DEPARTMENT OF TRANSPORTATION**Pipeline and Hazardous Materials Safety Administration**

[Docket No. PHMSA–2018–0080 (HM–265)]

Hazardous Materials: Advancing Safety of Highway, Rail, and Vessel Transportation

ACTION: Notice of proposed rulemaking (NPRM).

Figure 1: Section 178.345-8 Difference between Vertical Plane and Horizontal Plane

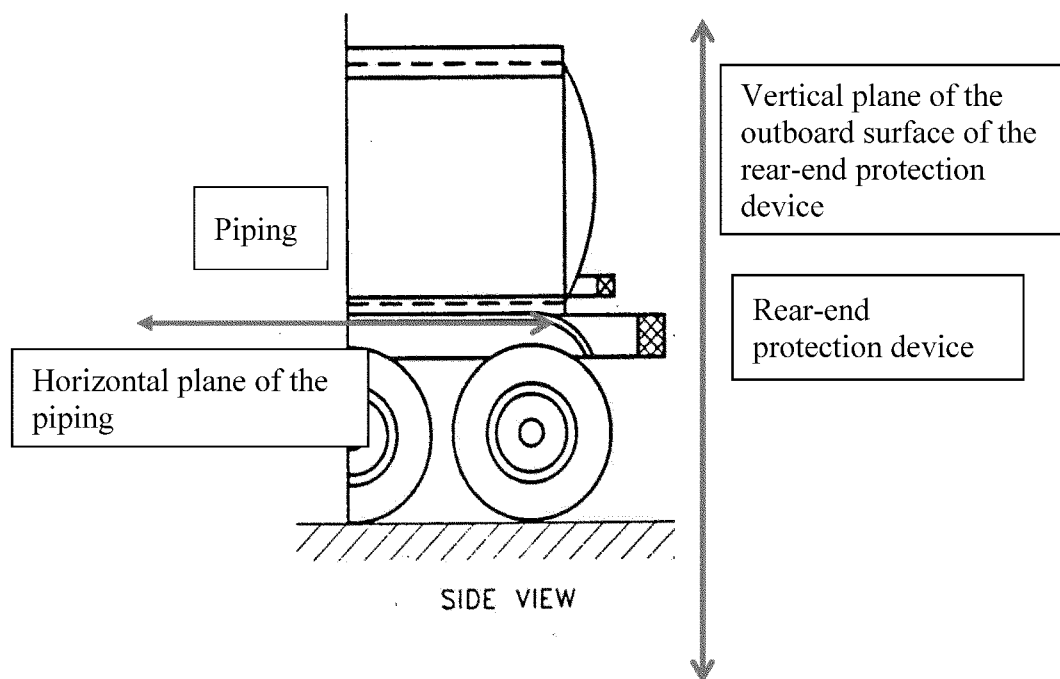
This section details accident damage protection for DOT Specification 406, 407, and 412 cargo tank motor vehicles. Paragraph (d) specifies rear-end tank protection, with paragraph (d)(1) describing design requirements for the rear-end cargo tank protection device. PHMSA proposes to split paragraph (d)(1) into two paragraphs—paragraphs (d)(1)(i) and (ii)—to better clarify

deflection design requirements and increase readability, which ultimately increases safety. PHMSA proposes that paragraph (d)(1)(i) contains the rear-end cargo tank protection device design requirements for cargo tanks where the rear-end protection device is on the same horizontal plane as the component. PHMSA proposes that paragraph (d)(1)(ii) contains design requirements for a rear-end cargo tank protection device when the component is not on the same horizontal plane. This proposed language is for clarification. Figure 1 details the difference between the vertical plane and horizontal plane.
